UNITED STATES PATENT AND TRADEMARK OFFICE

Office Action Summary	Application No. 10/500,905	Applicant(s) CLARINGBURN ET AL.
	Examiner LI LIU	Art Unit 2613

DETAILED ACTION

Figure O1

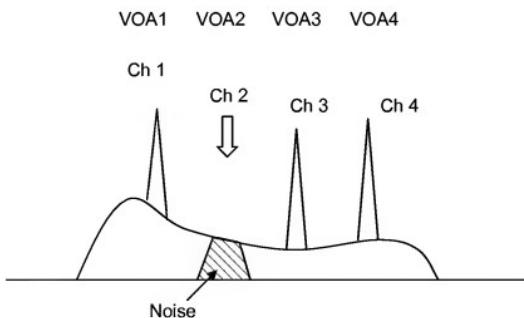
Examiner's response – Here is what the applicant discloses in "page 3, lines 17-19" of the specification: "In its broadest form the invention overcomes the problem by filtering out the EDFA noise on signal paths which have no add content and controlling the signal amplitude of the added signals after amplification". And in the detailed description, applicant also state "the multiplexer demultiplexer and VOA array is used to

block noise on channels that are not being added or used to control the added channels" (emphasis added) (page 6, line 22-24).

According to applicant disclosure, suppose there four signal paths (or channels) Ch1 – Ch4 in the system, and four variable optical attenuators (VOA1 – VOA4) are responsible for the four signal paths (or channels). While the channel Ch2 do not carry any signal to be added to the network, as shown in the position Ch2 in the following Figure O1, the signal path Ch2 has "no add content", and Ch2 in the signal path of the VOA2 has no any signal, or the channel Ch2 has no any wavelength signal. However, since the optical amplifier (e.g., 132 in Figure 2 or 140 in Figure 4 of applicant) is positioned before the VOA array, there is amplifier noise around the spectral position of Ch 2. That is, the "channel" (or signal path) Ch 2 carries amplifier noise, but does not have any signals to be added to the network. Then, the channel (Ch 2 in Figure O1), which has only noise, is blocked by the VOA2; and then the amplifier noise are filtered or blocked, and "improving or optimising the add channel OSNR" (page 3 line 14-15).

That is, the "blocking of channel" is to block noise in the signal path (or channel) since the "channel" has "no add content", and no corresponding wavelength signal is present in the "channel" or signal path.
